DAVIS-BESSE NUCLEAR POWER STATION, UNIT NO. 1

AMENDMENT TO FACILITY OPERATING LICENSE

Amendment No. 69 License No. NPF-3

ATTACHMENT TO LICENSE AMENDMENT NO. 69

Figure 3.1-2b. Regulating Group Position Limits, 24 + 10, -0 to 150 ± 10 EFPD, Four RC Pumps - Davis-Besse 1, Cycle 4

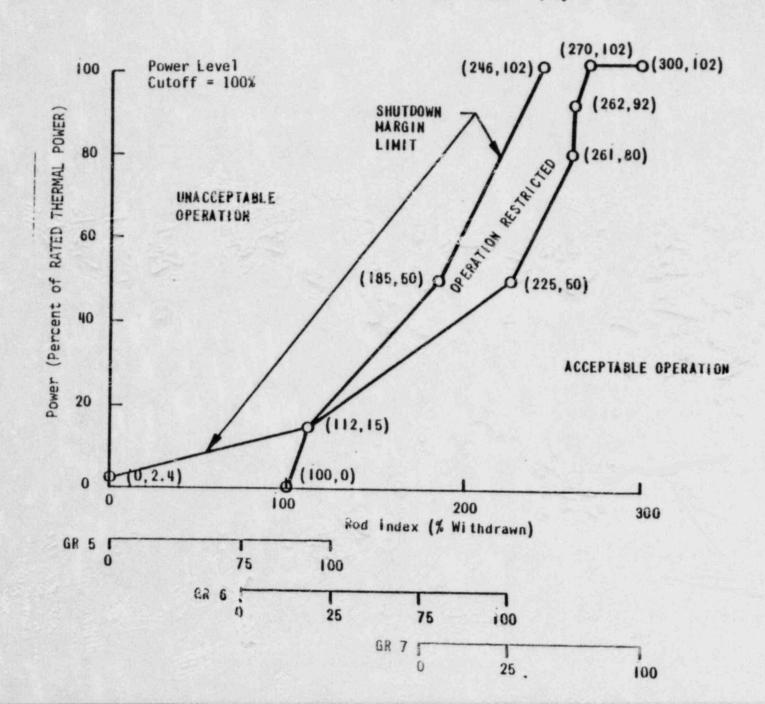
3.1.3.6 The regulating rod groups shall be limited in physical insertion as shown on Figures 3.1-2a, -2b, and -2c and 3.1-3a, -3b, and -3c for the first 200 ± 10 EFPD of operation. If the axial power shaping rods are completely withdrawn at 200 ± 10 EFPD for extension of cycle length, then the regulating rod groups shall be limited in physical insertion as shown on Figures 3.1-2e and 3.1-3e for the remainder of the cycle. However, if the axial power shaping rods are not completely withdrawn at 200 ± 10 EFPD, then the regulating rod groups shall be limited in physical insertion as shown on Figures 3.1-2d and 3.1-3d for the remainder of the cycle. A rod group overlap of 25 $\pm 5\%$ shall be maintained between sequential withdrawn groups 5, 6 and 7.

Figure 3.1-5c. APSR Position Limits, 150 ± 10 to 200 ± 10 EFPD, Four RC Pumps — Davis-Besse 1, Cycle 4

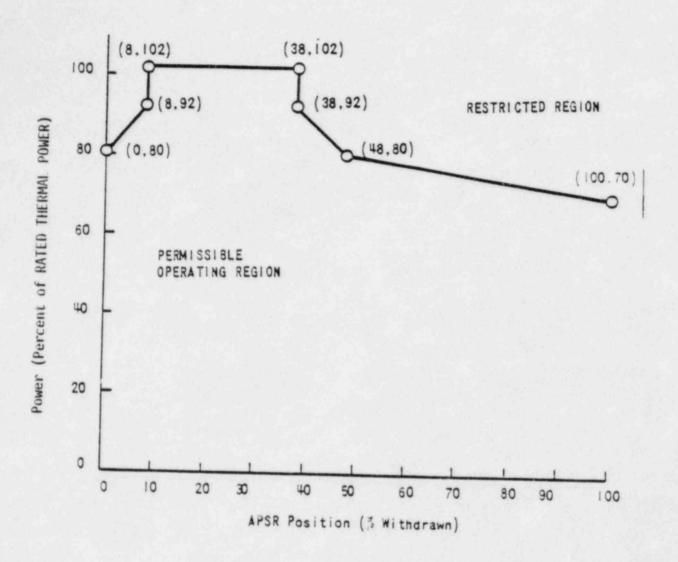
3.1.3.9 The axial power shaping rod group shall be limited in physical insertion as shown on Figures 3.1-5a, -5b, -5c, -5f, -5g and -5h for the first 200 ±10 EFPD of operation. If this rod group is completely withdrawn at 200 ±10 EFPD for extension of cycle length, it shall not be reinserted in the core for remainder of the cycle and the limits of Figure 3.1-5e shall be applicable. However, if the rod group is not completely withdrawn at 200 ±10 EFPD, the group shall be limited in physical insertion as shown on Figures 3.1-5d and -5i for the remainder of the cycle.

Figure 3.2-la. Axial Power Imbalance Limits, 0 to 24+10 -0 EFPD, Four RC Pumps — Davis-Besse 1, Cycle 4

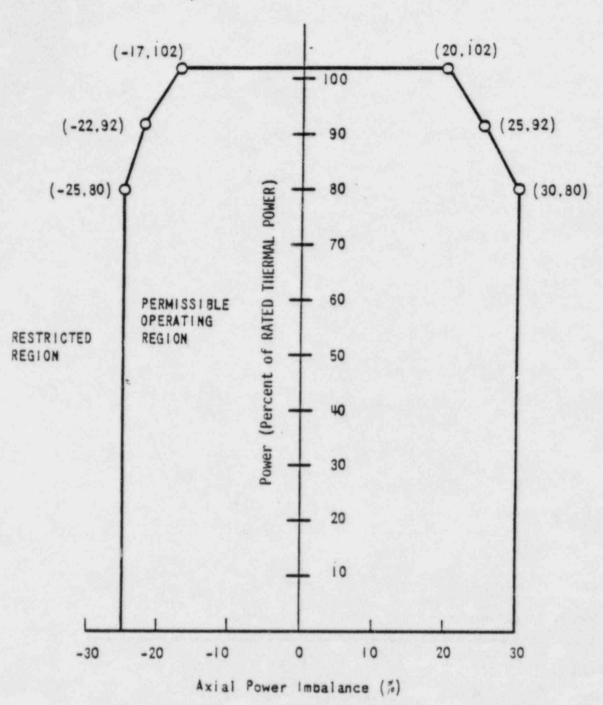
3.2.1 AXIAL POWER IMBALANCE shall be maintained within the limits shown on Figures 3.2-la, -lb and -lc and 3.2-2a, -2b and -2c for the first 200 ±10 EFPD of operation. If the axial power shaping rods are completely withdrawn at 200 ±10 EFPD for extension of cycle length, then the AXIAL POWER IMBALANCE shall be maintained within the limits shown on Figures 3.2-le and 3.2-2e for the remainder of the cycle. However, if the axial power shaping rods are not completely withdrawn at 200 ±10 EFPD, then the AXIAL POWER IMBALANCE shall be maintained within the limits shown on Figures 3.2-ld and 3.2-2d for the remainder of the cycle.
